DATE: September 21, 2010

FROM: Candace Havens, Interim Director of Planning and Development
Derek Valentine, Senior Planner

SUBJECT: BENJAMIN E. ABRAMS, Petition 105-09(2) for SPECIAL PERMIT/SITE PLAN APPROVAL for an accessory apartment within an existing one-family dwelling at 87 WOODWARD ST, Ward 5, NEWTON HIGHLANDS, on land known as Section 52, Block 1, Lot 27, containing approximately 12,786 square feet of land in a district zoned SINGLE RESIDENCE 2. Ref. Newton City Ordinances Section 30-8(d)(2), 30-19(i)(1), 30-19(m) and Table 30-8.

Zoning Review Memorandum

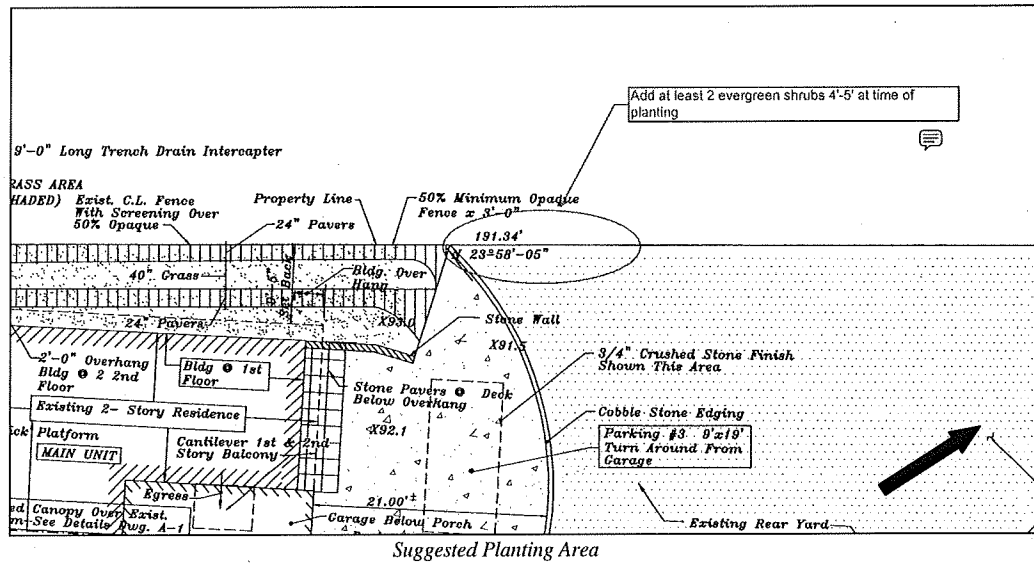
The site will remain essentially unchanged. In the front yard is a paved driveway with landscaped islands. On the west side of the property, a driveway exists which will access parking space #3 behind the residence. The driveway consists of grass with two strips of 24' pavers as treads (see picture below). The width of this access drive varies from 7'8" where it meets the existing driveway to 9'5" where it enters the back yard. There is a 9' x 19' crushed stone parking space located on the north side of the house.

The petitioner is proposing the addition of slats in the existing chain link fence to accomplish 50% opacity; however, ***the Planning Department strongly recommends that the petitioner provide some evergreen screening, buffering proposed parking stall #3 from adjacent properties, particularly where the opaque fence ends.*** No signage or lighting is being proposed at this time.

- The petitioner should provide screening on the western property line, to the north of parking space #3 (two 4-5 foot at planting evergreen trees to be approved by Planning Staff.)
- The petitioner shall use a template or other means to demonstrate that there is sufficient maneuvering space for access to parking space #3, or should expand the crushed stone maneuvering space in the rear of the house. Alternatively, the petitioner could relocate the parking space to the front yard, but this would require additional relief from the Board of Aldermen.
